City of Berkeley  
Echo Lake Accessibility Upgrade  
Specification No. 23-11590-C  
Addendum #3

This addendum provides answers to questions received to dates.

## CITY OF BERKELEY BERKELEY ECHO LAKE CAMP

# L1.01

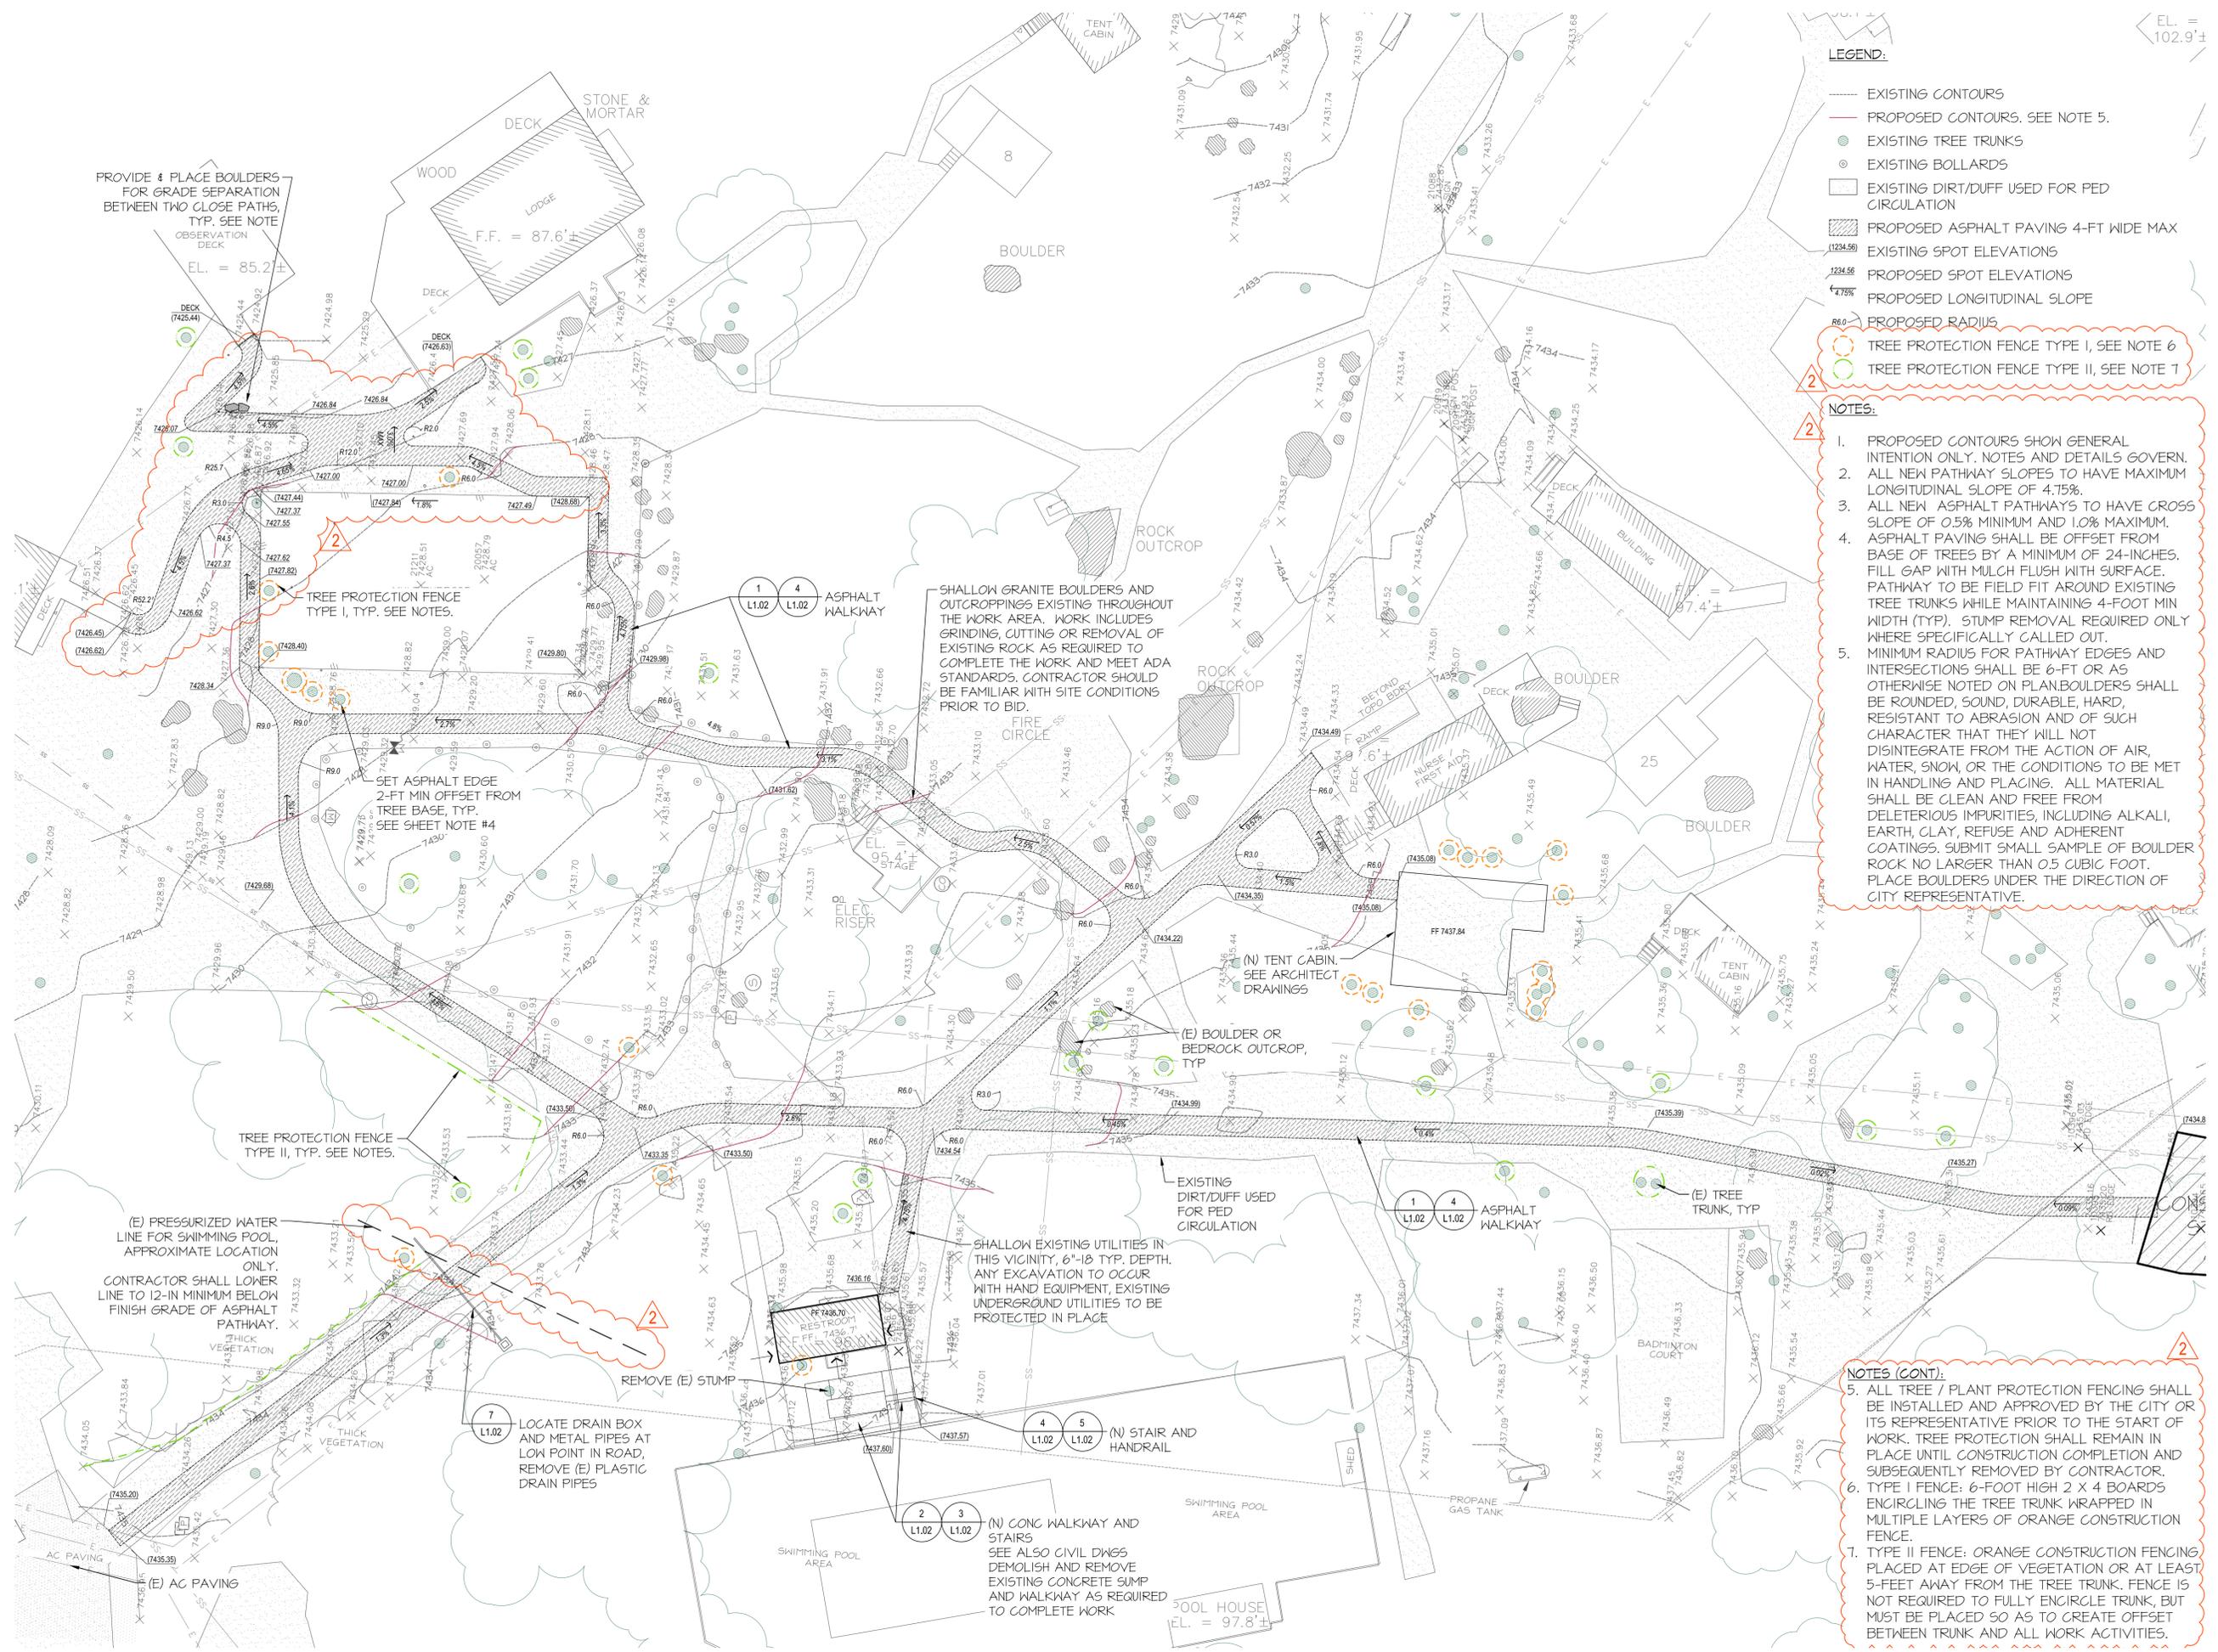
- 2) Revised Sheet L1.01 (attached) as follows:
  - a) Include tree protection
  - b) Corrected grading
  - c) Corrected approximate location of (E) Pressurized Water Line

Question #14: Is there any tree protection required?

Question #15: Are there any requirements related to construction fencing for vegetated or environmentally sensitive areas?

*City Response: Yes. See attached revised Sheet L1.01.*

*City Response: See revised Sheet L1.01 for tree protection requirements. Contractor is not allowed to impact vegetation during course of construction. Exclusionary fencing (i.e. orange plastic construction fencing) may be required at the sole direction of the City Project Manager if Contractor access, staging, or construction operations do not adequately protect against vegetation impacts during the course of work.*

**9 BOULDER PLACEMENT**  
SCALE: 1" = 1'-0"

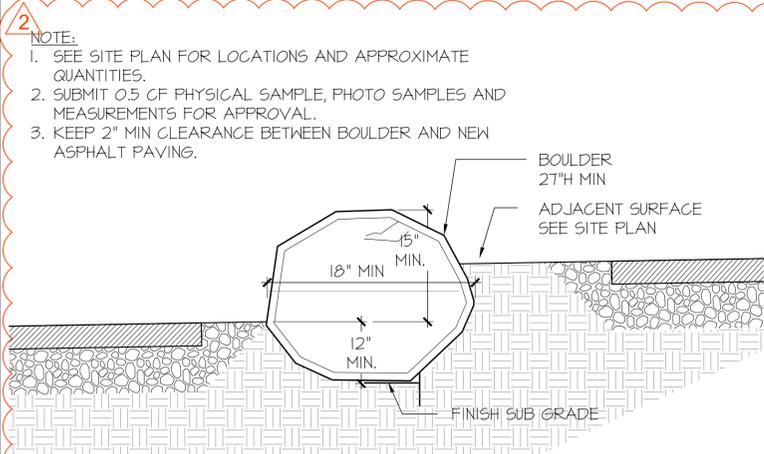
- 1) Revised Sheet L1.02 (attached) as follows:
  - a) Revised "Asphalt Paving with Aggregate Base" Detail
  - b) New Detail for 'Asphalt Path at Rock Outcrop'
  - c) New Detail for 'Boulder Placement'
  - d) Revised numbering of Details on Sheet L1.02

**Addendum #3**  
**Sketch #1**  
○ Assumed rock removal areas

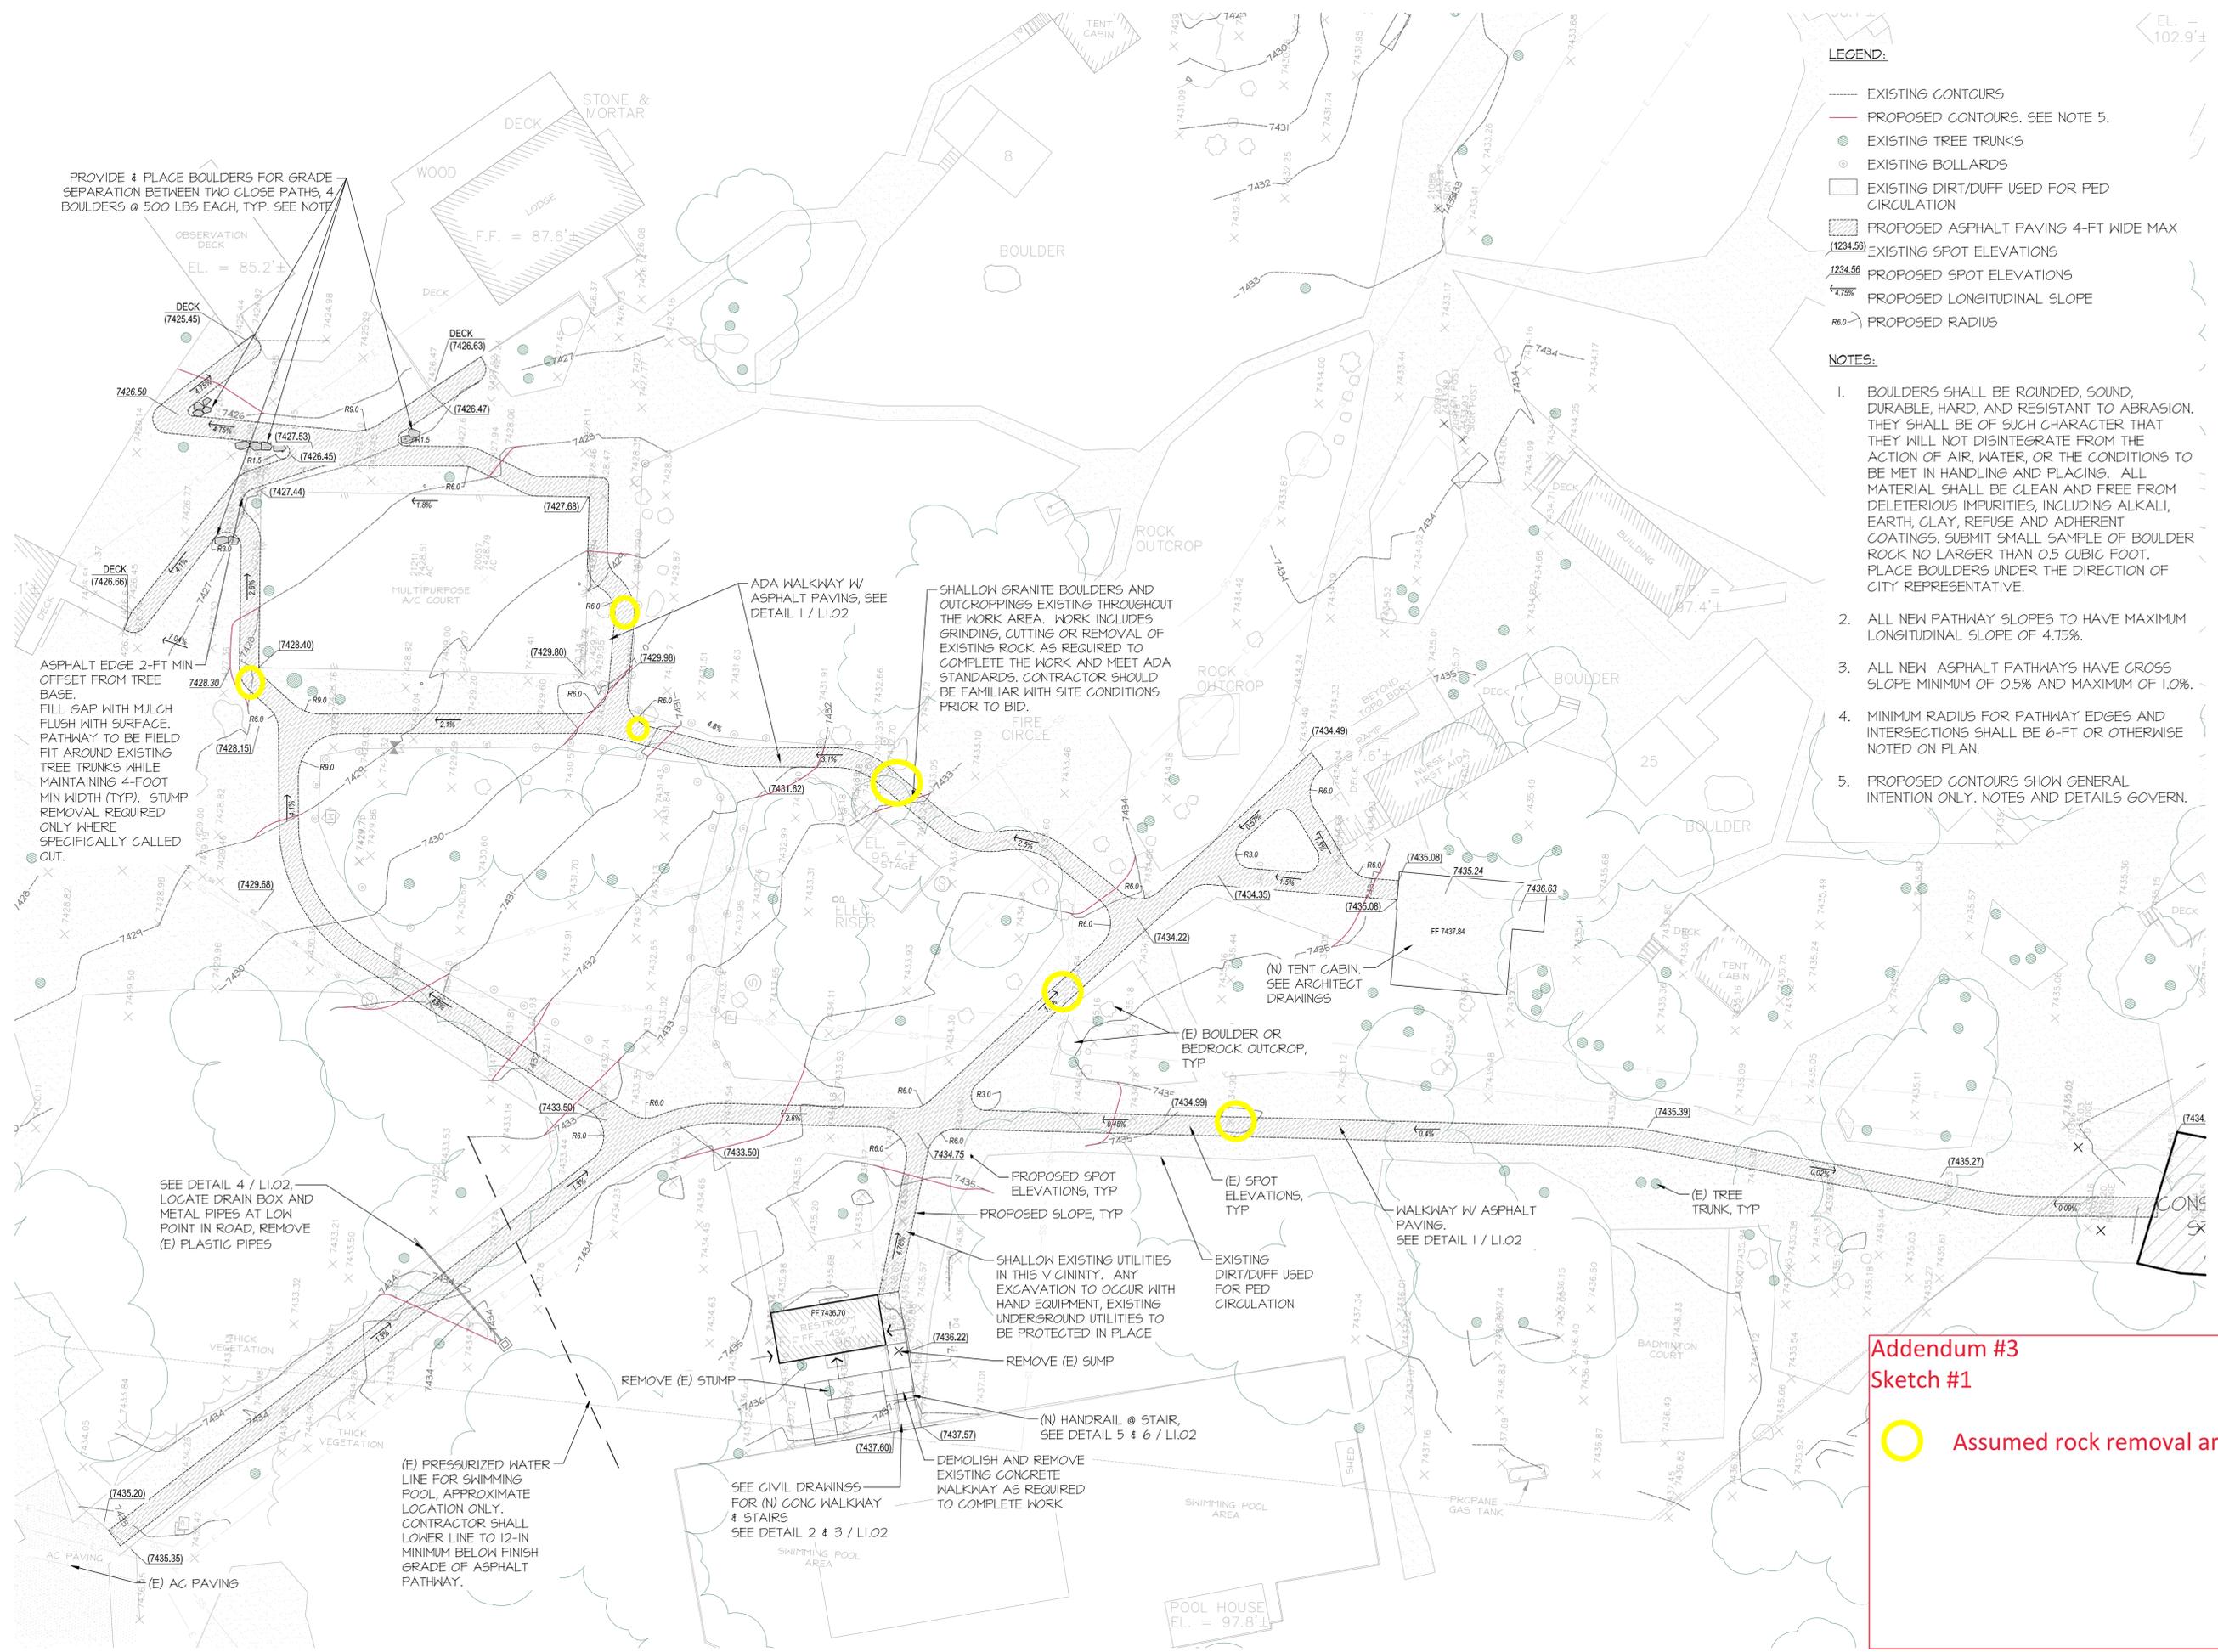
Question #10: Given that we cannot access the site, how should we proceed with estimating the amount of rock work (removal, grinding, etc.) required for pathway construction for bidding purposes?

*City Response: Contractor shall assume rock is present in locations circled in green in attached Sketch #1. City Project Manager will work with Contractor to make field adjustments to path layout and/or width to minimize rock conflicts to the maximum extent feasible. If the total rock encountered (regardless of actual location) exceeds that which is indicated in Sketch #1, additional rock will be considered a changed condition and removal authorized to occur on a time & materials basis (with completed detailed backup to verify actual time and costs required).*
